RHODE ISLAND CONTRACT NO.2021-CT-062

Intersection Safety Improvements 2019 C2

NOTICE TO PROSPECTIVE BIDDERS

ADDENDUM NO. 3 Prospective bidders and all concerned are hereby notified of the following changes in the Plans, Specifications, Proposal and Distribution of Quantities for this contract. These changes shall be incorporated in the Plans, Specifications, Proposal and Distribution of Quantities, and shall become an integral part of the Contract Documents.

1. Sheet No. 5 - Job Specific Legend & Notes

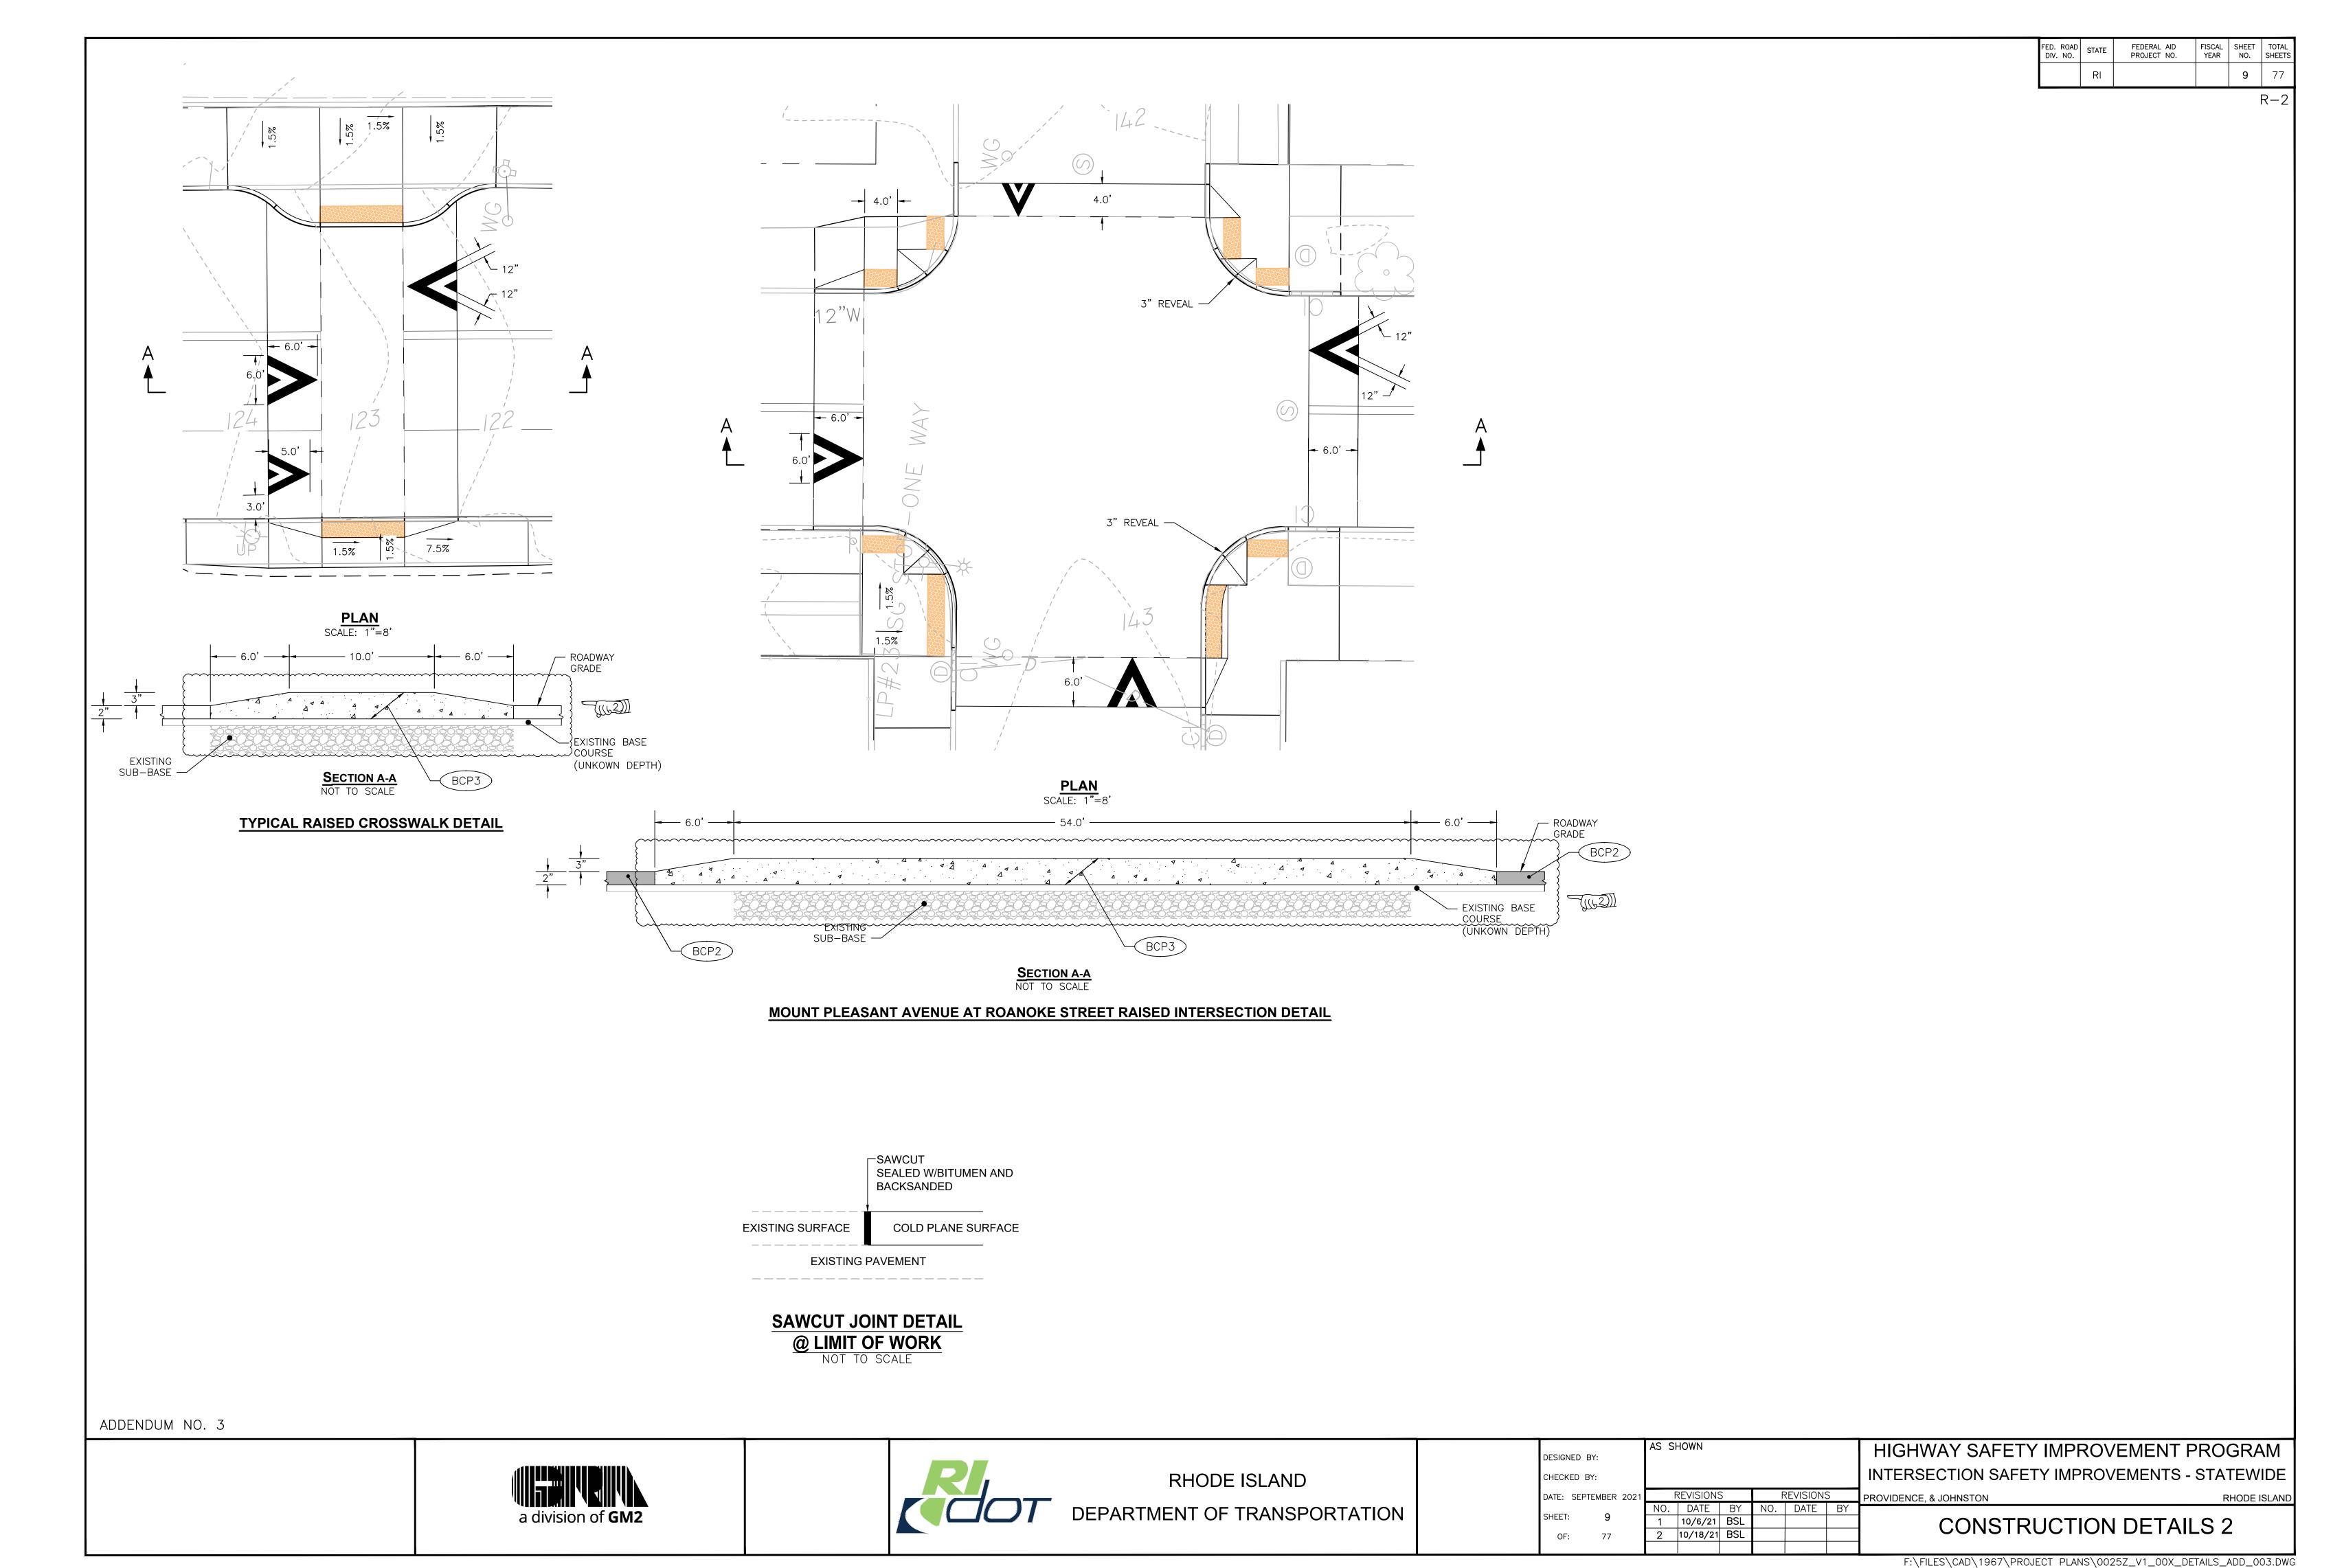
Delete Sheet No. 5 in its entirety and replace it with Revised Sheet No. 5(R-2), attached to this Addendum No. 3. The legend has been revised.

3. Sheet No. 12 - Mount Pleasant Ave - Typical Sections

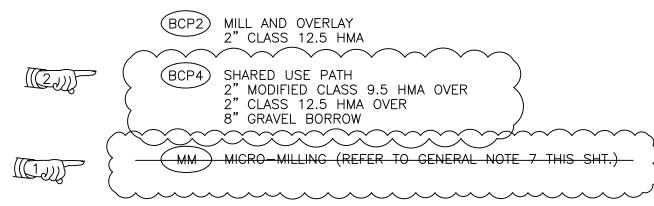
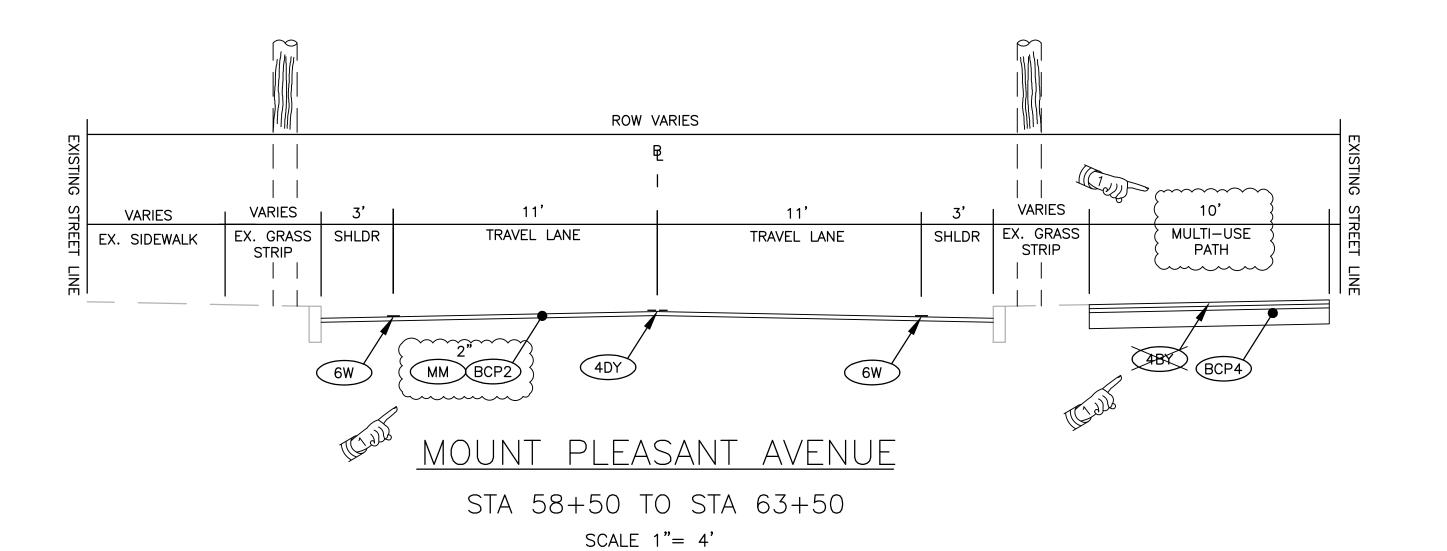
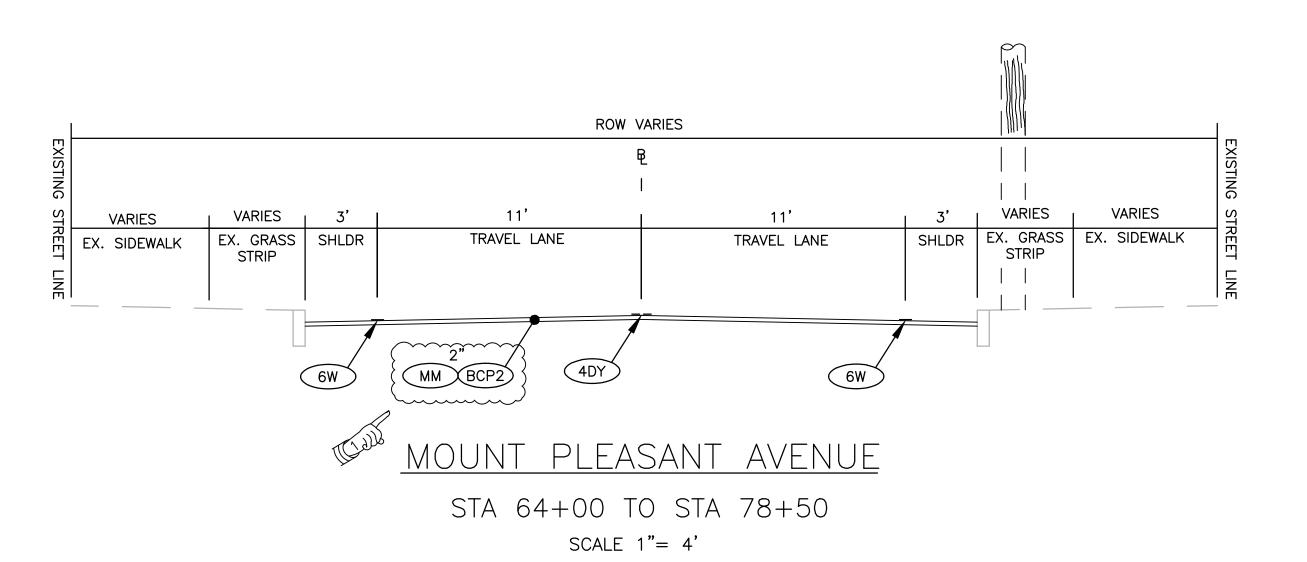
Delete Sheet No. 12 in its entirety and replace it with revised Sheet No. 12(R-2), attached to this Addendum No. 3. The pavement legend and details have been revised.
